Re: Cleveland Innerbelt Study (PID 77510)  
I-90 East Alignment Study  
Technical Memorandum

December 20, 2023

Figure 5 – Pier placement concern for the St. Clair Avenue bridge over existing and proposed I-90

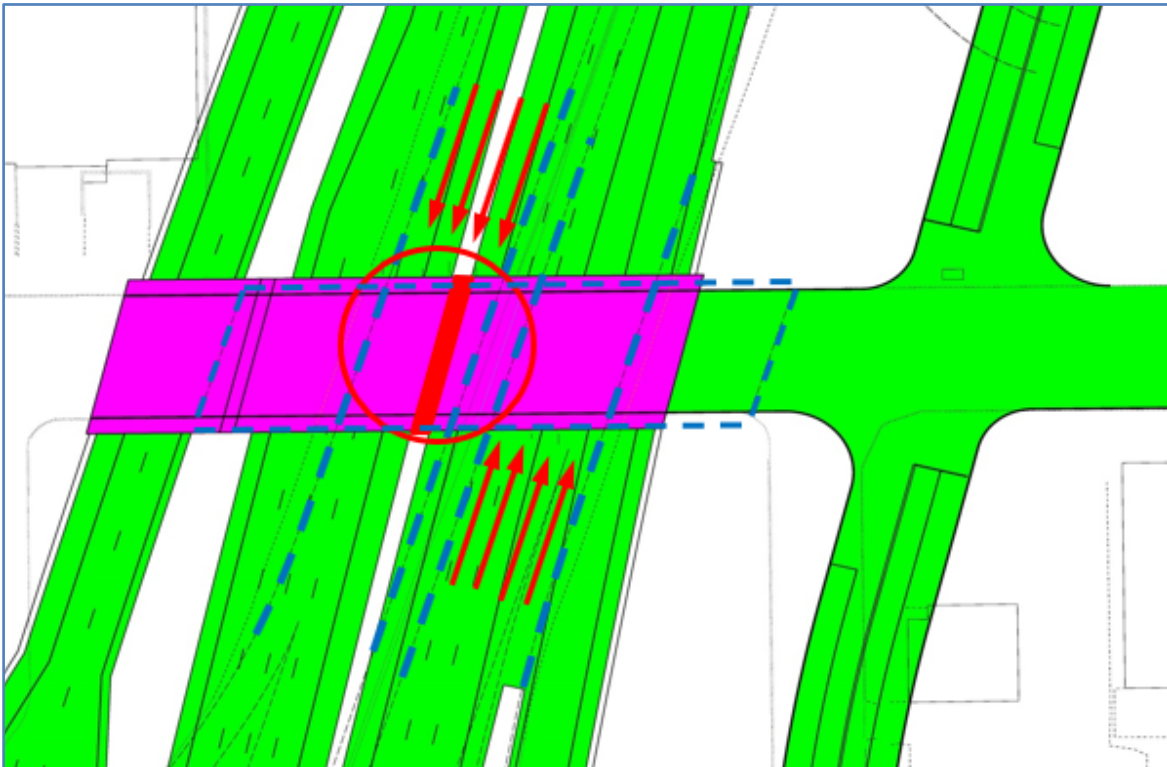
Possible additional alternative: Consider using a temporary prefabricated single-span bridge to maintain one lane (with a directional detour for opposite direction) or two lanes (one lane each direction) on St. Clair while proposed I-90 is constructed so the existing bridge can be removed as discussed below. This was done on the Maumee River Crossing project in ODOT D2 to maintain a city street connection over IR-280 during major reconstruction and realignment of the pavement.

How is this option impacted if a SMART lane is constructed I90 WB in first phase of CCG4?

**Figure 6 – Pier placement concern for the Hamilton Avenue bridge over existing and proposed I-90**

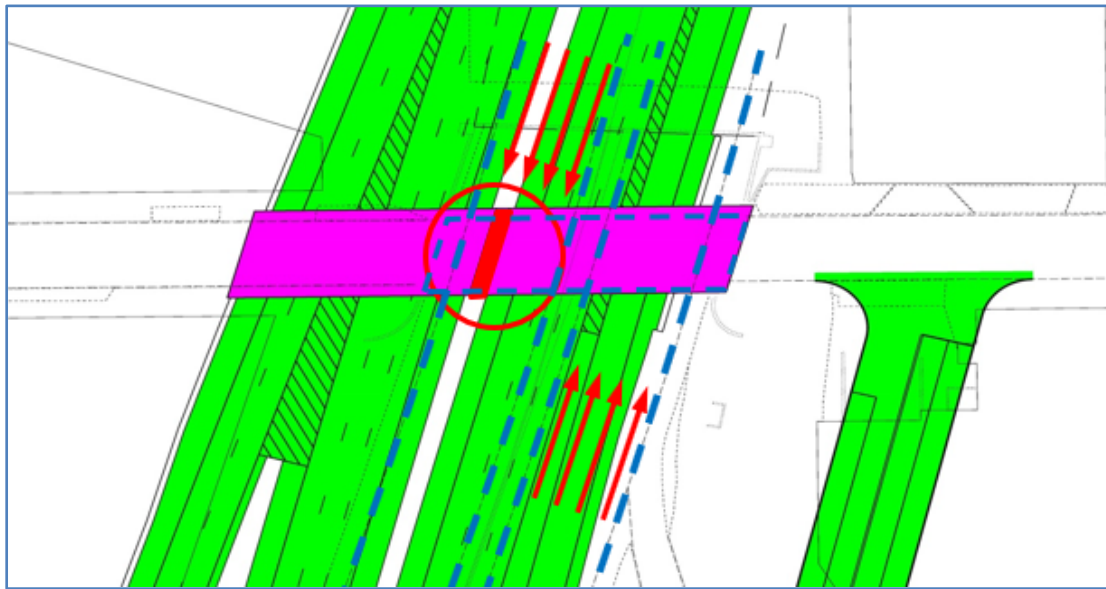
Possible additional alternative: Consider using a temporary prefabricated single-span bridge to maintain one lane (with a directional detour for opposite direction) or two lanes (one lane each direction) for Hamilton Avenue. See comments for St. Clair.

How is this option impacted if a SMART lane is constructed I90 WB in first phase of CCG4?
